Northacre Renewable Energy Facility

Northacre Renewable Energy Limited

Schedule 5 Response

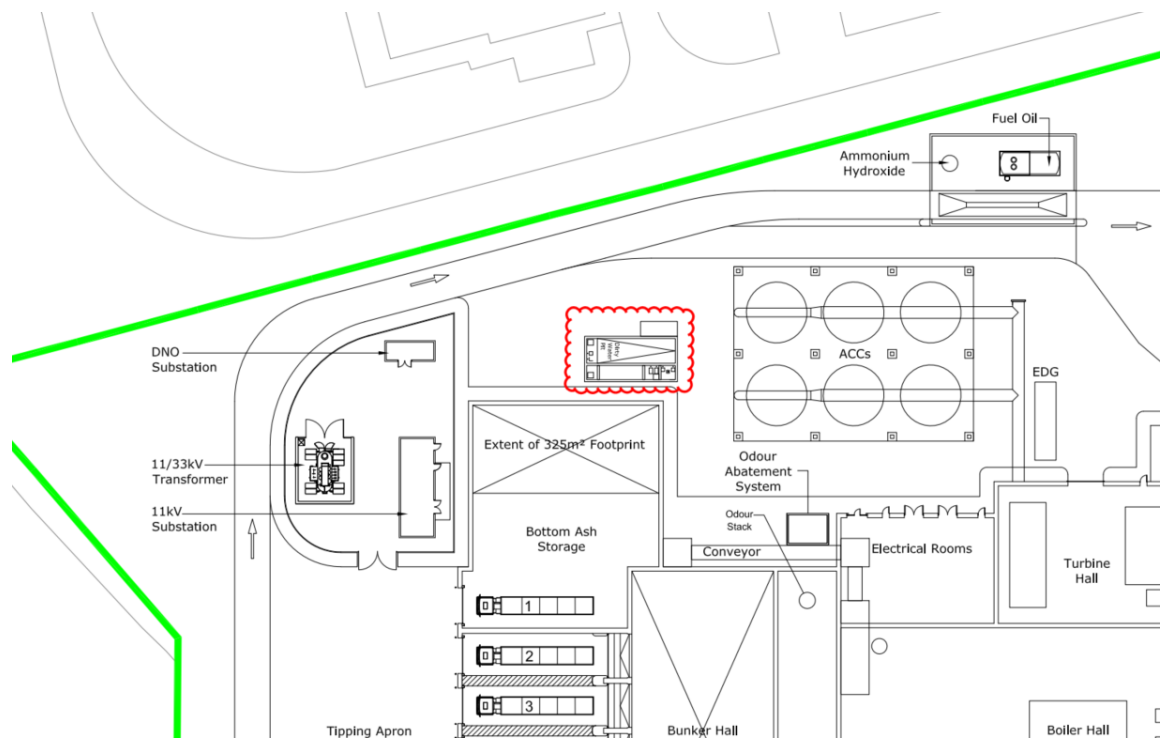
3. Explain how the environmental impact of the incinerator will be affected by operation with waste at the expected minimum calorific value shown on the firing diagram.

The dispersion modelling is based on the thermal capacity/input to the boiler of 90 MWth. This is the thermal capacity of the boiler as shown in the Firing Diagram presented in Appendix A of the EP Application. As stated in section 6.3 of the Air Quality Assessment, the model inputs which correlate with the 'nominal design capacity' were '*based on the combustion of 32.5 tonnes per hour of residual waste with a net calorific value of 10.5 MJ/kg*' – this equates to a thermal input of 90 MWth.

As shown in the firing diagram, the boiler is designed to process waste with a range of NCV's (8 - 14 MJ/kg). These variations in NCV have been allowed for within the design basis of the combustion calculations which have been used to determine the model inputs. Therefore, assuming that the Facility receives waste with an NCV at the lower end of the range (i.e. 8 MJ/kg), it will be capable of processing up to 41.1 tph of waste. This is equivalent to a thermal input of 90 MWth. Therefore, whilst the minimum NCV shown on the firing diagram has not been specifically modelled, it is within the design parameters which have been used to determine the model inputs.

Fichtner has previously undertaken sensitivity analysis for various points of a firing diagram. This has shown that there is a very small change (<1%) to the air quality impacts associated with a range of NCV waste at the thermal capacity/input to the boiler. The change in NCV of the waste can be due to changes to any of the following three parameters:

Depending on which parameter is changed to achieve the relevant NCV, the air quality impacts can increase or decrease slightly as the NCV changes. Therefore, Fichtner does not consider that it is appropriate to assume that a higher throughput (at a lower NCV) will necessarily result in an increase in air quality impacts.

High Level Transfer Conveyor Concept.

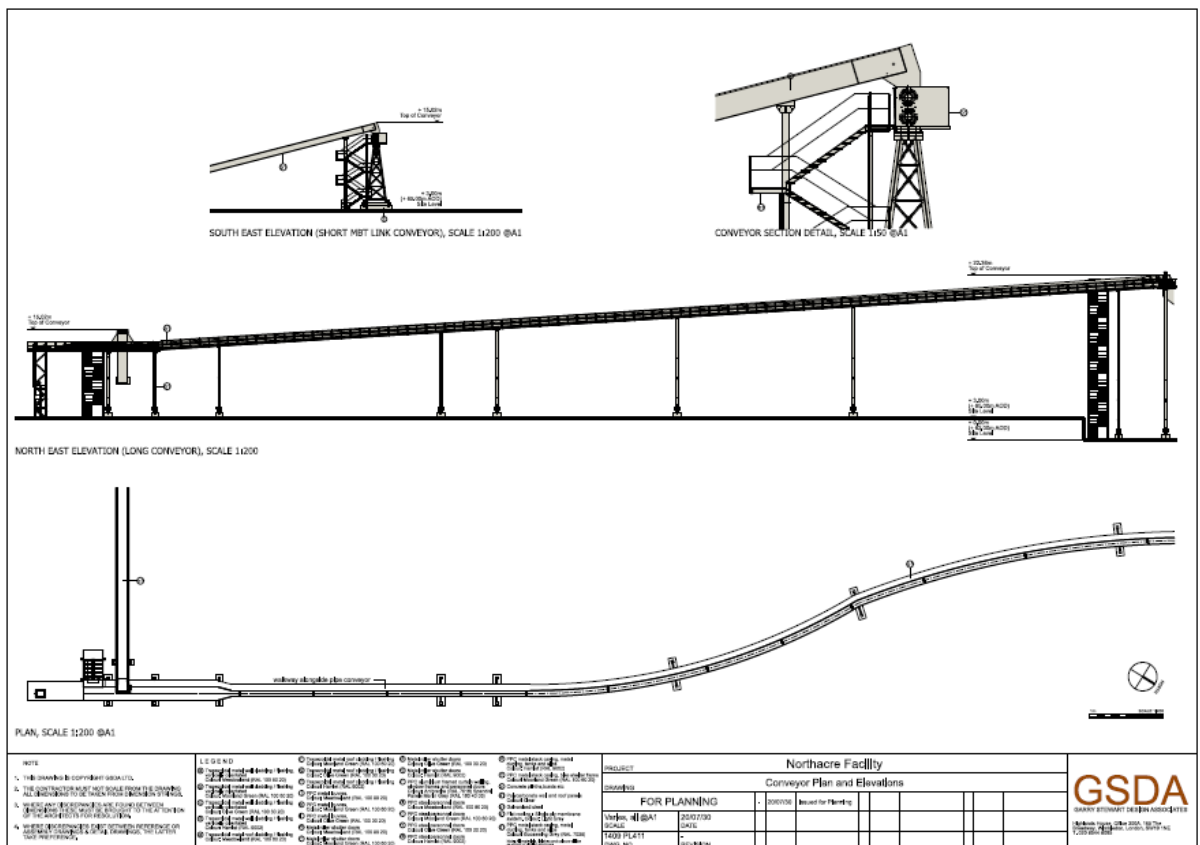
11. Provide details of the proposed waste conveyor delivering waste from the adjacent MBT plant. Explain how the conveyor will be controlled and explain the waste acceptance and pre-acceptance procedures.

NRE and Hills Waste Solutions Ltd (Hills) are proposing to use a high-level transfer conveyor to transport some or all of these waste outputs directly from the MBT Plant to the Facility for disposal, without the use of vehicles. It should be noted that Hills Waste Solutions Ltd will be the ‘Operator’ of the conveyor, and it will not be implemented until a variation to the EP for the MBT Plant has been granted by the EA for its operation. A separate application for an EP variation will be submitted by Hills Waste Solutions Ltd for the operation of the conveyor, and it is not intended to form part of this application.

Whilst the design of the conveyor is subject to detailed design, an indicative drawing of the transfer conveyor concept is provided below.

The waste outputs from the MBT plant will be conveyed to a single elevating conveyor which starts within the MBT building, and elevates the materials to the start of the high-level conveyor, at the top of a support tower with staircase access and lifting access. The elevating conveyor will be fully enclosed. The waste outputs will be transferred from the elevating conveyor to the high-level transfer conveyor at an enclosed transfer point, and conveyed to the Facility.

The high-level transfer conveyor will end at a support tower adjacent to the Facility, complete with staircase access and lifting access. At the support tower, the material will be transferred from the high-level transfer conveyor to an enclosed transfer conveyor or conveyors which will transfer the waste outputs to the via a feed hopper(s) into the waste bunker. There will be a weighing belt and a manual sampling point in the conveyor system between the high-level transfer conveyor and the bunker to enable monitoring of the quantities of waste received from the MBT facility and to enable sampling of the incoming waste from the MBT plant.
